**AGENDA
TECHNICAL REVIEW COMMITTEE (TRC)
August 4, 2026
10:00AM**

**DEVELOPMENT REVIEW LETTER
GOLD KEY ROOFING
VARIANCE AND MINOR SITE PLAN
7/1/2026**

Project Name: Gold Key Roofing Variance & Site Plan

CITY OF FRUITLAND PARK
STAFF REVIEW REPORT BY LPG URBAN & REGIONAL PLANNERS, LLC

SITE PLAN

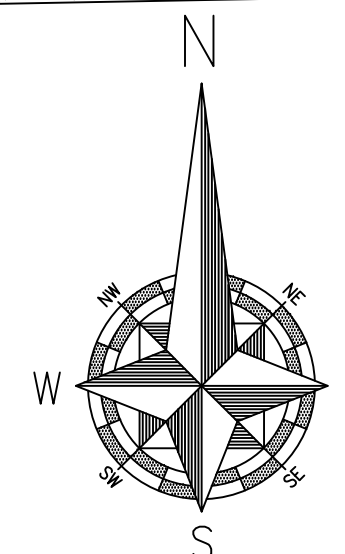
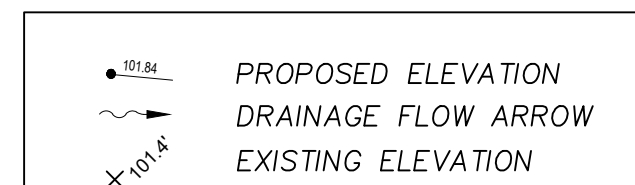
1. Please include stop bar and stop sign locations on the Site Plan.

Please use attached detail to meet minimum dumpster pad requirements as indicated by Scott.

Please modify the enclosure dimensions to meet the requirements below. 10'x10' is not adequate.

Leesburg will reject the site plan. Leesburg will require 10' easement along Fountain St, as well as along Citrus Bv/441. The existing poles will need to be removed due to the retaining wall going in. We will need to know where the new service will be located and how it will be fed. The best option would be for them to install an underground electric service out to the property line. They can contact me at 352-728-9822, or by email at Steve.Davis@LeesburgFlorida.gov to discuss the easement and service size, voltage and location.

Per Chapter 164, Section 164.030(a) landscaping is required at the end of all parking rows of a minimum of 200 SF and contain a minimum of 1 canopy tree, five shrubs and ground cover or grass. The site plan does not indicate any proposed landscaping at the end of all parking rows.

landscape buffer. The site plan should be revised to show a proposed 13.6' setback and a proposed 5' buffer with a solid fence. Parking spaces are allowed within the setback; however, they are not allowed within buffer areas.

Per Chapter 154, Section 154.060(a) – A 25' landscape buffer is required from the right of way. The subject site has right of way adjacent to the eastern and southern boundaries. The 25' buffer requires 5 canopy trees, 4 understory trees, and 30 shrubs per 100 linear feet. A 5' sidewalk is required within the established buffer unless a sidewalk already exists. The site plan does not indicate any proposed buffers. The site plan indicates that there is an existing concrete walk adjacent to the eastern boundary and no sidewalk is proposed adjacent to East Fountain Street. Review of the topo and google maps indicate that there is a severe slope adjacent to the northern and eastern boundary. Review of the site plan indicates a retaining wall is proposed adjacent to the eastern and southern property boundary. A variance would be required to allow for no buffers or reduced buffers or architectural planters. Please clarify all variances that are being requested.

The site plan indicates building landscaping area of 3' adjacent to the proposed office/warehouse. However, there are no landscaping plans indicating the proposed planting. No building landscaping is proposed adjacent to the existing storage building.

Bicycle parking is required for the office use at 0.10 per required parking space. Based on the number of required office parking, 1 bicycle parking space is required. The site plan shows a bike rack figure; however, it does not appear the site plan indicates the placement of the bike rack.

The site plan should include the dumpster detail and location of dumpster on the site plan. Please also advise if any tree removal is proposed.

It does not appear that the vehicle use area provides for a fire truck turnaround (i.e. T-turn). Planning staff defers to city engineer and/or fire reviewer.

The enclosures should be 12'x12' with the interior clearance being 12' and not the exterior dimensions. The doors for the enclosure should swing to a full 180 degrees and not stop at 90 degrees. They should have drop pins and holes drilled to secure the pins in the closed and open position for the doors. The main thing to consider here is ensuring the hinges are installed on the posts so they allow the doors to open and do not become trapped on the posts so to speak. If curbing is being installed to the side of the enclosure, just ensure the opening on the bottom of the door will clear it when opening the door. The caveat would be if a 2nd dumpster is desired for trash or even recycle, that the enclosure is built 24' wide instead.
